APPLICATION FOR PERMISSION UNDER SECTION 16 OF THE TOWN PLANNING ORDINANCE (CAP.131)

For Official Use Only 請勿填寫此欄	Application No. 申請編號	A / N7-F7A / 201
	Date Received 收到日期	18 DEC 2020

Hong Kong Chilled Meat & Poultry Association 香港冰鮮家禽業商會

PlanPlus Consultancy Limited

Figure 4.3: Decking over the Existing Watercourse (Normal Operation during Non-Heavy Raining)

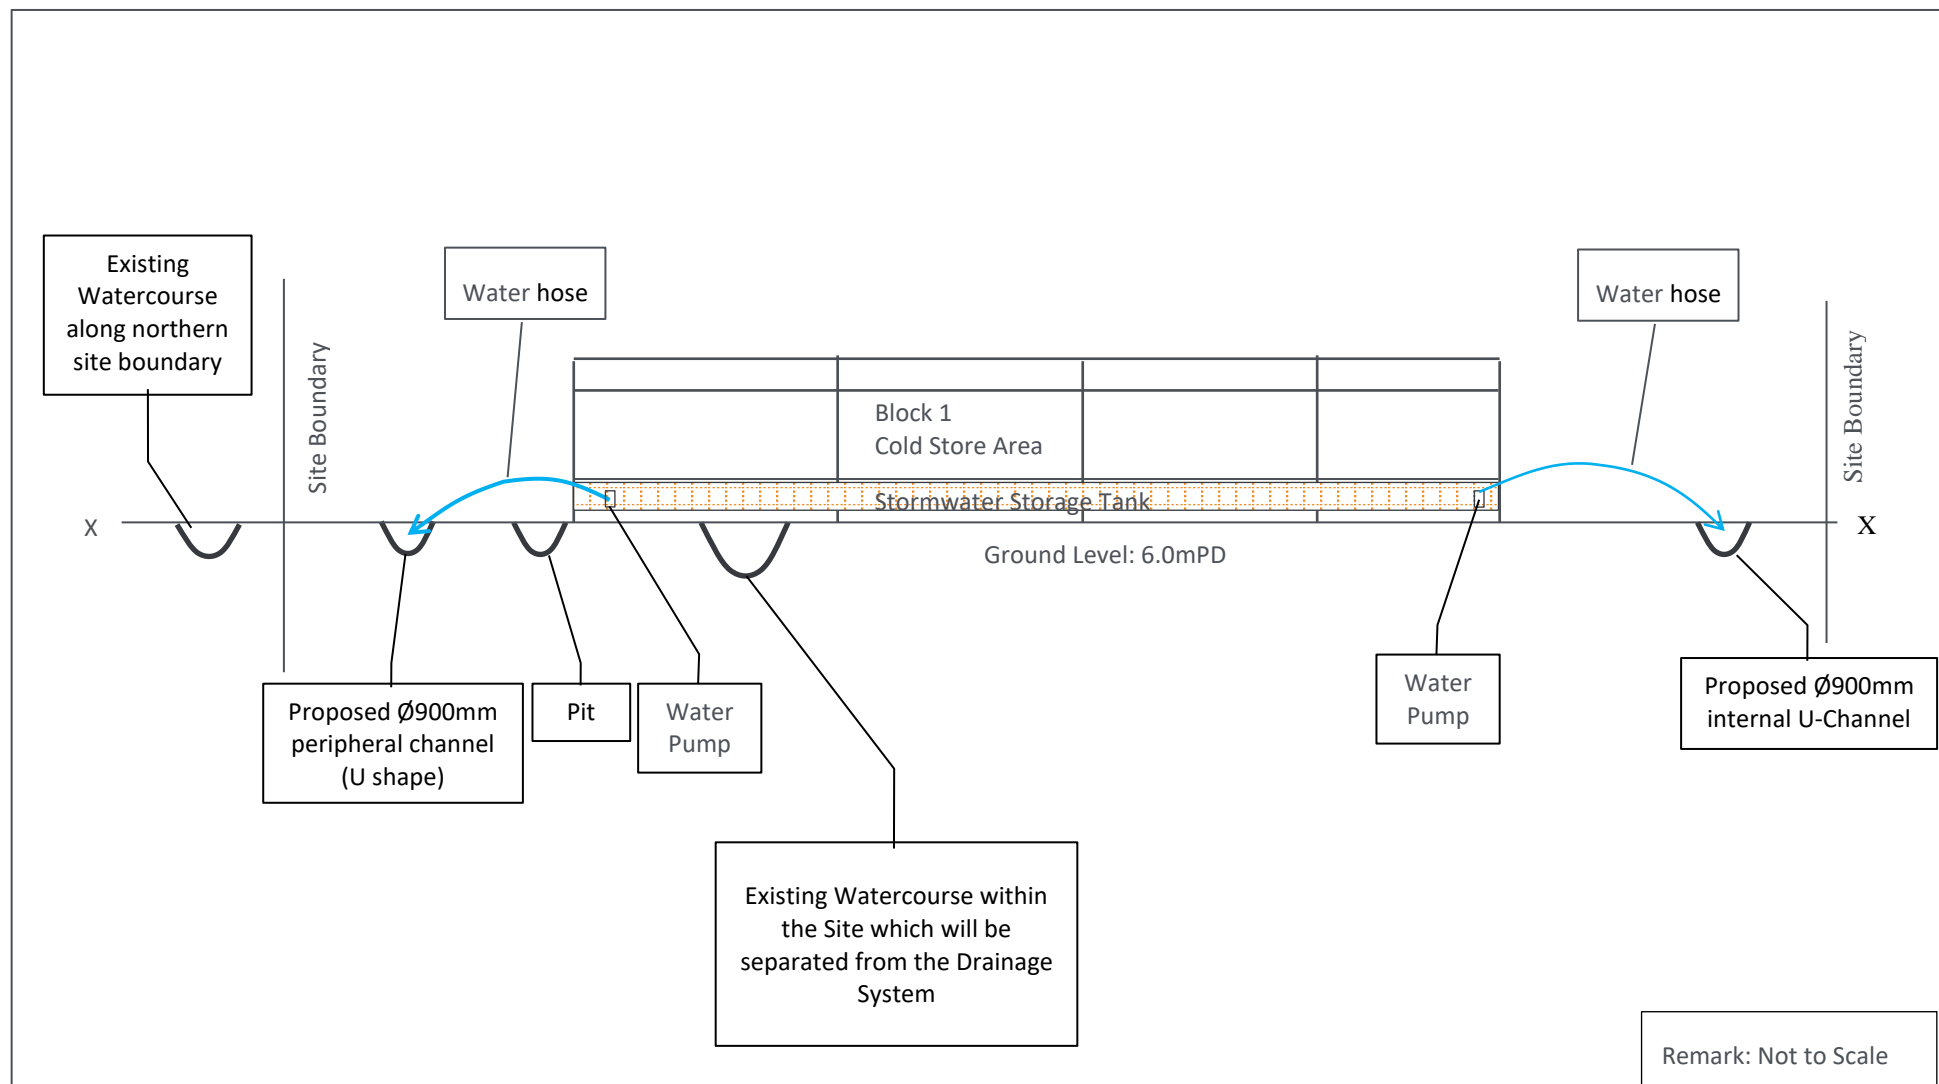
(b) Please clarify if storm water from U-channel(s) would be pumped to stormwater storage tank during heavy rainfall only. If positive, please clearly state the arrangement during normal operation.	The runoff from U-channel will be pumped to stormwater storage tank during heavy rain only. Figure 4.2 has been revised to show the arrangement during heavy raining while a new Figure 4.3 has been prepared to show the arrangement during non-heavy raining.

(c) Besides, separate section plans for normal operation and during heavy rainfall should be provided.	Figure 4.2 has been revised and a new Figure 4.3 has been prepared to provide two separate sectional plan for normal operation and operation during heavy raining.

Figure 4.4: Indicative Drainage Layout (Operation during Heavy Raining)

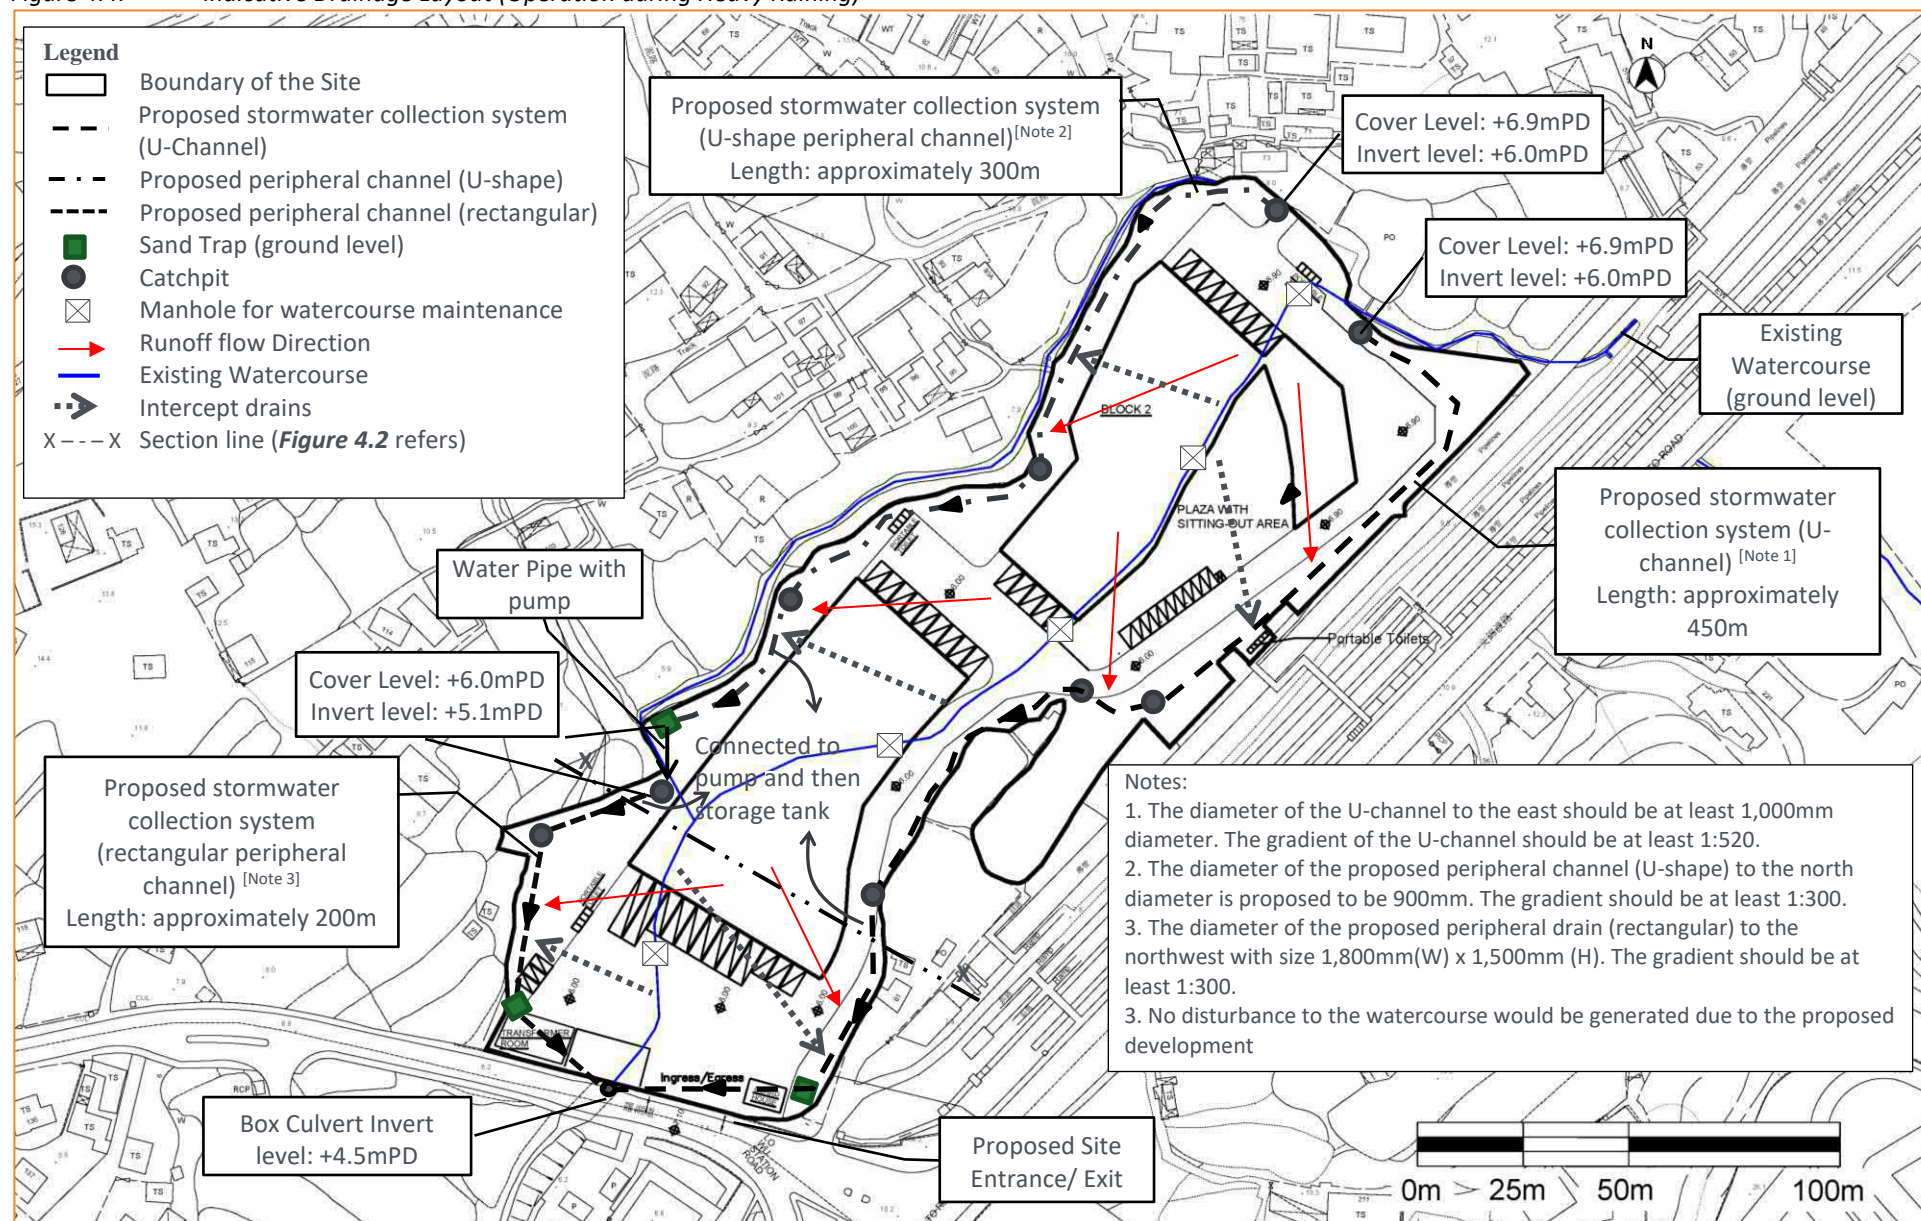
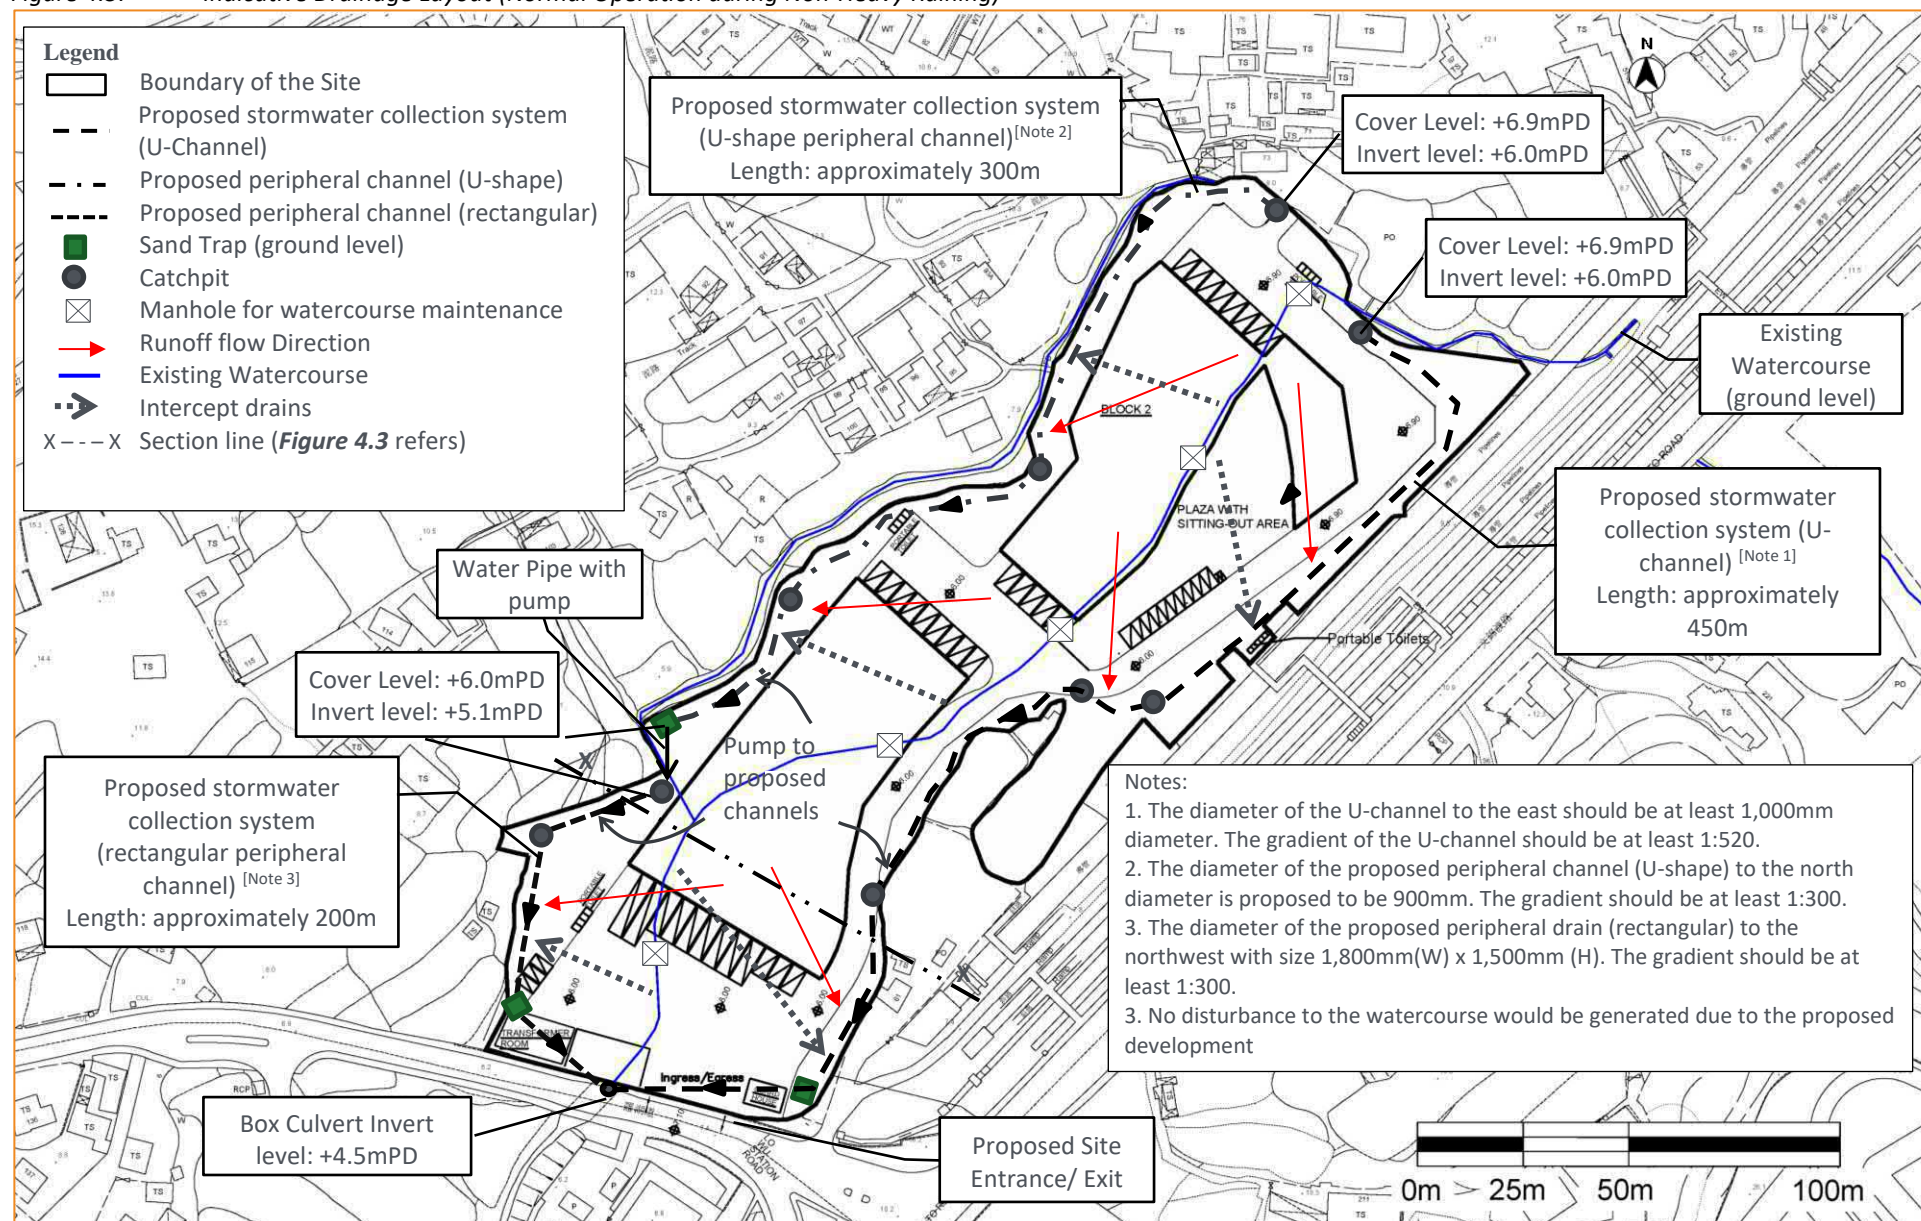
11. S.4.4.10 – Please review the repeated description about collection of runoff.	Noted and para. 4.4.10 has been revised.
		12. S.4.4.10 – Please clarify “existing box culvert via the underground pipe connecting to the outfall when emergency, which installed with silt/ sand traps and oil interceptors”	As mentioned in the revised para. 4.4.10, the stormwater will be diverted and discharged into existing box culvert via prpopsed channels as shown on the revised Figures 4.4 and 4.5.
